HISTORIC DISTRICT COMMISSION ADDITIONAL INFORMATION REQUEST

Application Number: HDC2025-00464

PROJECT ADDRESS: 2025 Orleans Street

HISTORIC DISTRICT: Lafayette Park/Mies van der Rohe

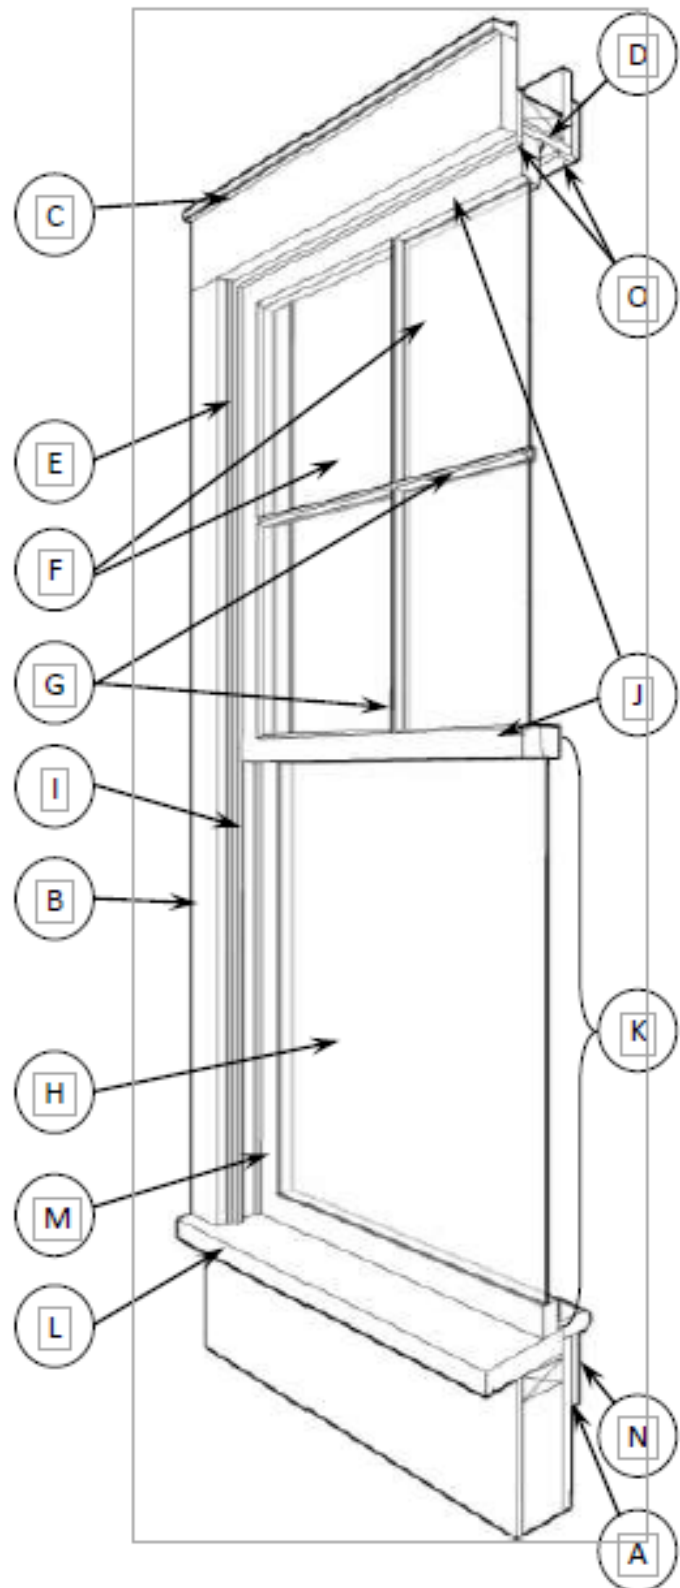
1. Include interior photos of the existing windows.
2. Close-up images showcasing where damage occurs.
3. Section drawings with dimensions and materials of existing windows (see the example drawings attached below).
4. Section drawings with dimensions and materials of the proposed windows.

1. See attached interior photos.
2. See attached photos of damaged areas. These photos demonstrate cracked glass, water leakage on floors, inability to lock windows without the use of wood or a bar, seal leakage, lack of argon gas and general failure.
3. See attached images of the patio door which is 84 inches wide by 80 inches tall. The stiles are 2.5 inches wide and the rails are 4 inches wide. The picture window is 58" x 58" and is mulled to a bottom gliding one panel window at 58" x 34". The rails and stiles are 2.5". All material is aluminum and/or other metal components.
4. See attached images of the proposed design. Same dimensions apply as in No. 3. The Andersen 100 series material is its patented Fibrex.
